From: Carpenter, Alan (P.E.) <acarpenter@cphcorp.com>
Sent: Monday, May 24, 2021 1:13 PM
To: Margaret Washburn
Cc: Carpenter, Alan (P.E.); Heidi Carpenter; president@local882.org; Eric Strandson
Subject: RE: Kausch and Son - Wetland Application 041321D - 23 White Brook Drive Abutter input.
Attachments: Kausch Wetland Application Review Letter 5-24-21.ARC.pdf; pg 3 Kausch - Church Street Eng Plan with Comments 5-24-21.ARC.pdf; Kausch - Church Street survey with Comments 5-24-21.ARC.pdf; Kausch Wetland App and DEP form with Comments 5-24-21.ARC.pdf

RE: Kausch & Sons LLC Lots 019-37-17, 019-37-20 & 019-37-21
Wetland Application 041321D

The above input has been provided based on my review of plans dated 4-30-21 and application information obtained from the applicants filings for the project. I would like the ability to review and comment on any future plans or supporting document submittals.

Property Survey
Prepared For:
A. Kausch & Sons LLC
Church Street & Pomfret Landing
Brooklyn, Connecticut

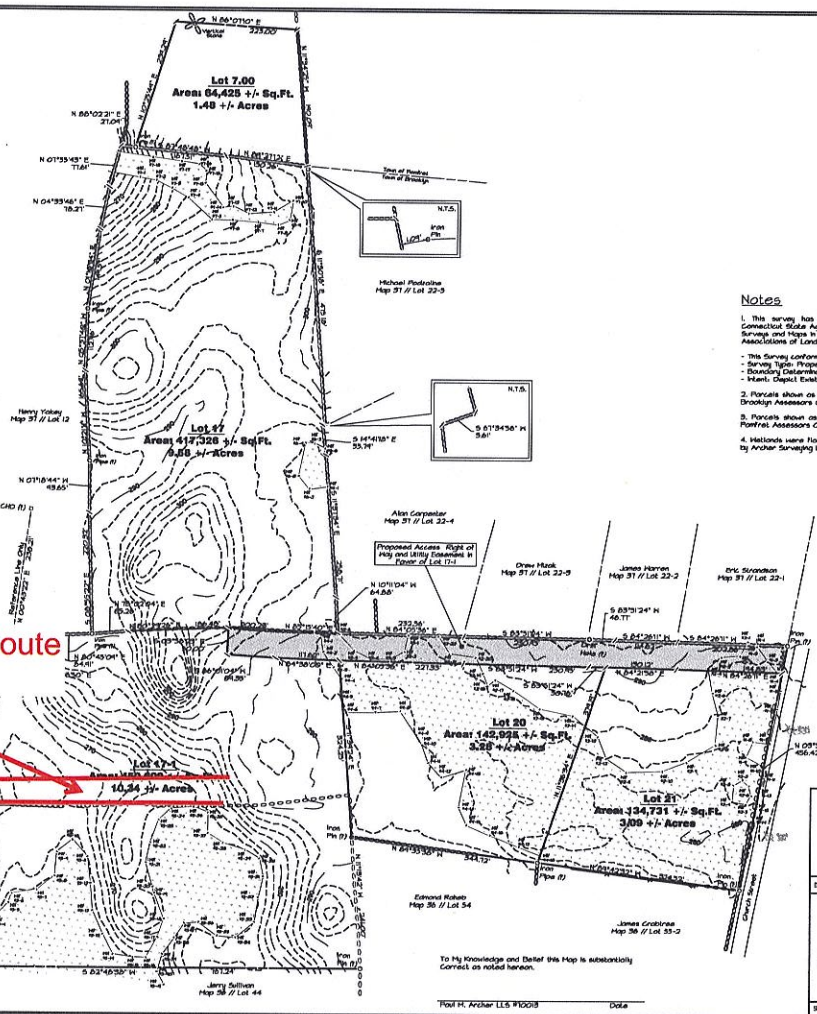
6. Pursuant to Brooklyn Inland Wetlands and Watercourses Regulations Section 7, 7.5f. There does not appear to be any discussion or depiction of 'Alternative which would cause less or no environmental impact to wetlands or watercourses'. By my review of the plan, it appears that such an Alternative does existing in the access strip to Pomfret Landing. That 'Alternative' does not appear to have any wetlands along that route and therefore NO wetlands would be impacted by that route. (see attached sketch). It should at least be shown on the plan as an Alternative. The Soil Scientist report addresses it but the plan does not show the wetland or its limits. Without that information being located and quantified, that Alternative should not be discredited.

**Alternate Driveway Route
no wetland impacts**

GRADING & SITE DESIGN

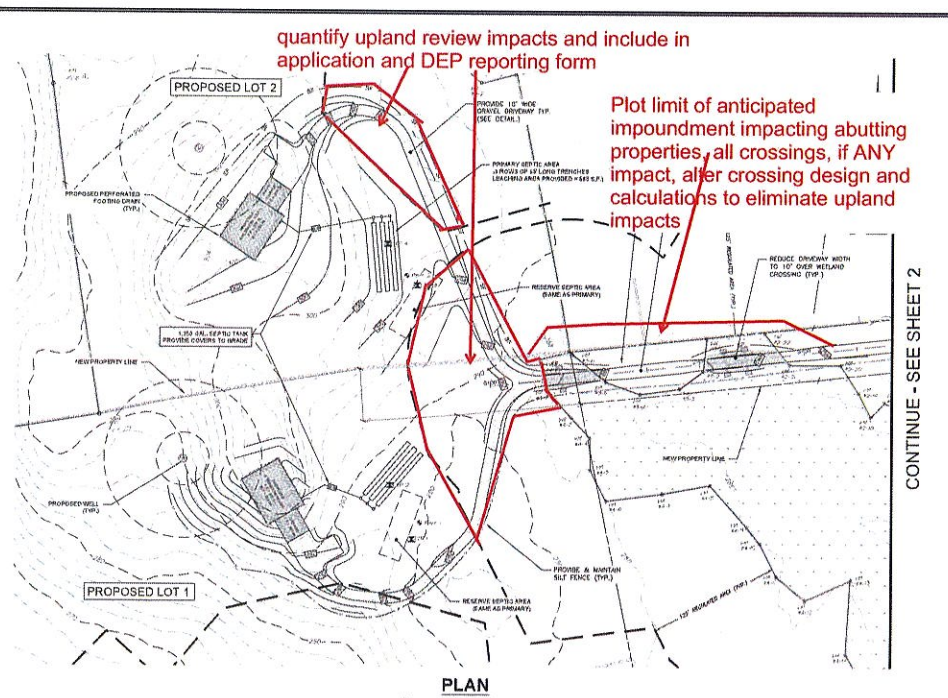
7. Pursuant to Brooklyn Inland Wetlands and Watercourses Regulations Section 7, 7.5g, there does not appear to be any discussion on the additional impacts caused by the proposal. While the plan shows the proposed driveway and the engineering of the proposed driveway grading and drainage with minimization of impacts at the wetland crossings, there does not appear to be a proposed 'limit of disturbance', nor any ancillary utilities (power and communications) line locations, at a minimum. These utility installations to service the proposed structures will likely cause additional impacts and disturbances to the wetlands, not currently shown. That additional necessary infrastructure should be shown and its additional impacts considered in the plan and decision. In addition, there does not appear to be any roadside grading consideration for the conveyance of overland water flow from the abutting properties to the north. If this is not addressed the proposed driveway may cause an impounded or run-off and potentially negatively impact the abutting land and its owners.

for the pipe crossings. There appears to be a conflict between the summary table and the Culvert Report summaries particularly for crossing number 2. The summary report shows '3X15' where the Culvert Report appears to only model for '2X15'. Because there are numerous upland properties potentially impacted by the impoundment, the plans should be modified to demonstrate NO impact on the abutting properties. The plan and profile detail for the culvert crossings should be provided in more detail as it appears that when the design storm is applied and the headwater condition elevates as modeled the run-off water will likely bypass the culvert and potentially washout (erode) the driveway east and west of the culvert crossing. The use of elliptical pipes may help keep the headwater profile as low as possible or moving the driveway south could reduce the potential impact of the impoundment on the abutters.
